Subject: Dresden Station Units 2 and 3
 Drywell to Torus Vacuum Breakers
 Dresden Station Special Report No. 23A,
AEC Dkts 50-237 and 50-249

DRESDEN STATION SPECIAL REPORT NO. 23A

Supplemental Information Concerning Dresden Units

2 & 3 Drywell to Torus Vacuum Breakers

FIGURE I

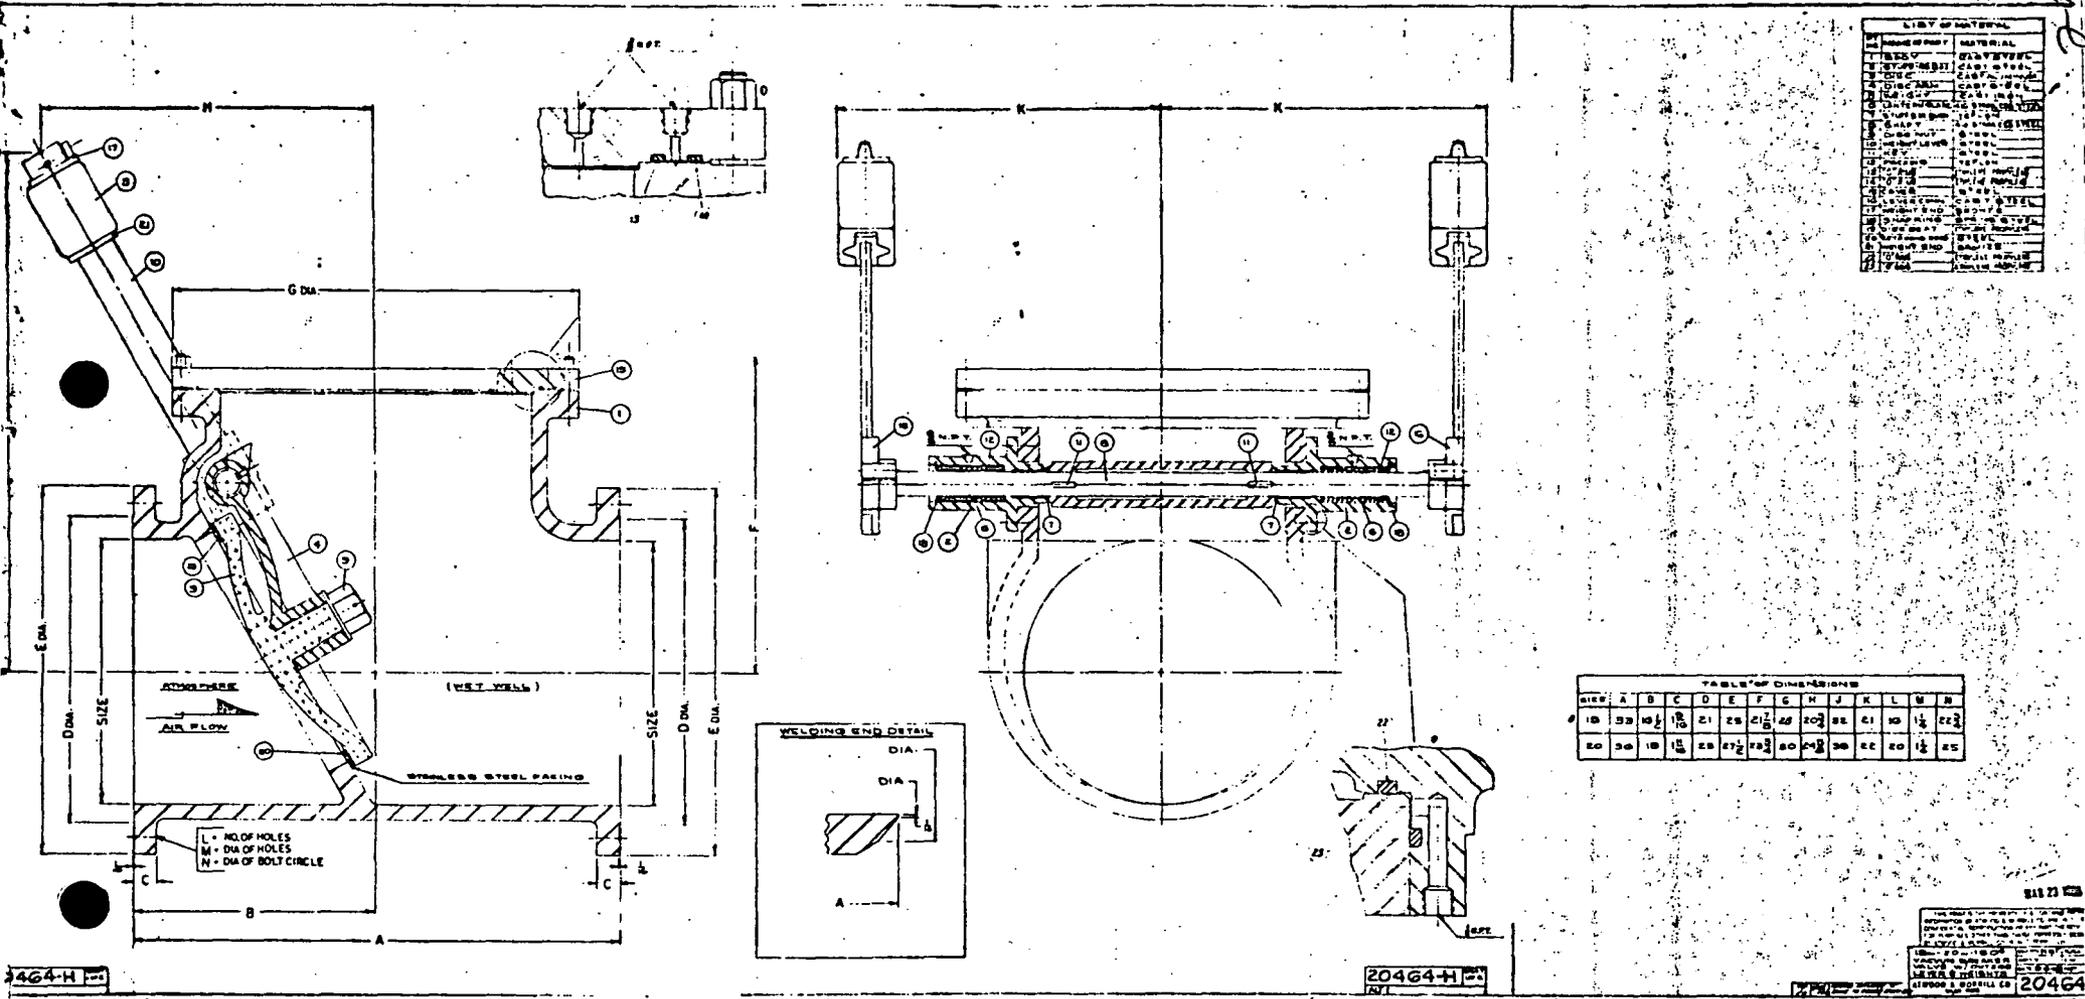
Upon disassembly of the valves, it was determined that the discs of some of the valves were not squarely seating due to corrosion between the disc and the disc arm. The corrosion closed up the clearance between these pieces and prevented the disc from properly aligning with the seat. Referring to Figure 1, it can be seen that the disc is held onto the disc arm by means of an integral post or hub and a nut. Due to the corrosion, extreme difficulty was experienced in disassembling the disc from the disc arm. Attempts at separating these pieces caused failures of the post or hub flush with the rear surface of the disc or at the base of the threads for the retaining nut on several valves. The disc material is cast aluminum and the disc arm is cast steel. There was a fairly sharp corner at the base of the post and it is theorized that the lack of an adequate radius was at least partially the cause of failure. A compounding cause of failure is attributed to the seizure of the disc and disc arm. Normal closure of the valve with adequate clearances would place the base of the post in simple compression. However, the seized joint prevented proper alignment resulting in the force of closure of the valve continually being taken at the same point on one edge of the disc. This placed a bending stress on the base of the post in the area of the sharp corner every time the valve was cycled. Surveillance frequency on these valves had been increased from monthly to weekly in the light of the difficulties with the Quad-Cities valves and prior experience with the sticking of the bushings as reported in Special Report No. 23. It should be noted that all failures were caused during the disassembly and no failures were evident in the as found condition of the valves.

All twelve valves on Unit 3 underwent modification to prevent future recurrence of this problem. The posts were cut off of the discs and the discs faced on both sides to obtain true surfaces.

Redesigned post assemblies were obtained from the manufacturer of the valves. The new posts were machined from 304 stainless steel and were threaded on each end. The discs were bored to accept the new posts and the disc was attached to the post with a nut which was then locked in place. The posts were assembled to the disc arm with a high temperature, low chloride, anti-seize compound to preclude future corrosion and subsequent seizing.

Schematic Representation of 18" Vacuum Breakers on Dresden 2 and 3

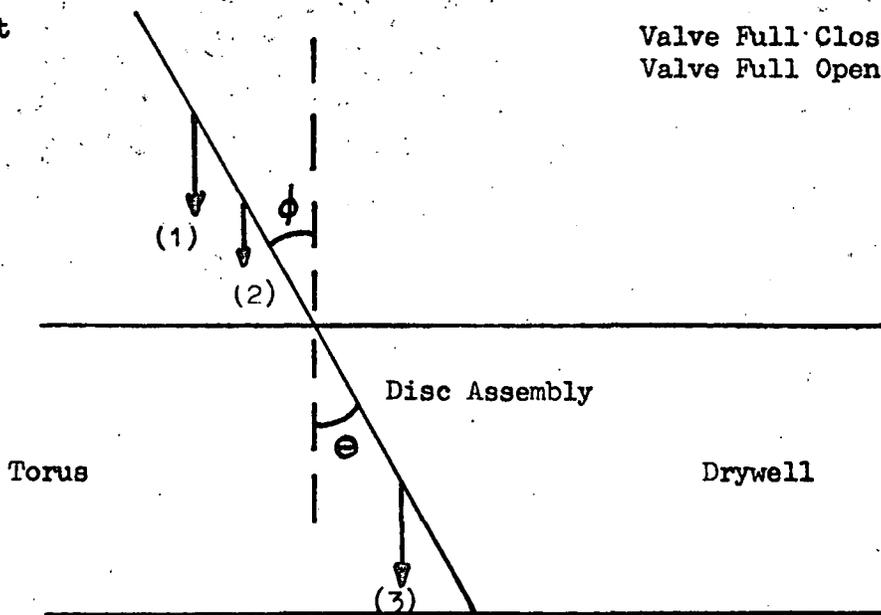
During the course of these modifications it became evident that the counterweight assembly on Dresden 3 also differed from that reported in Special Report No. 23. The counterweight configuration described in that report does indeed exist at the present time on Dresden 2. The Dresden 3 system utilized twenty-five pound weights as opposed to ten pound weights and had considerably longer counterweight arms. Consequently, modifications were in order in this area also.

One of the two counterweight arms and twenty-five pound weights were completely removed from each valve. The remaining arm was rotated 20° to a position 10° from vertical with the valve in the fully closed position. This configuration is contrasted with the original configuration of Dresden 3 in Figures 2 and 3. While the Dresden 2 counterweights are presently as reported in the Special Report, and are now technically acceptable, they will undergo modification to make them identical to Dresden 3. In addition to making the counterweight assemblies similar, it will increase the range of counterweight adjustment and yield identical limit switch installations. This modification is to be accomplished by August 31, 1973. The Dresden 2 valves will undergo modification of the discs to accept the redesigned posts and new ethylene propylene seats will be installed during the next refueling outage, presently scheduled for fall of 1974.
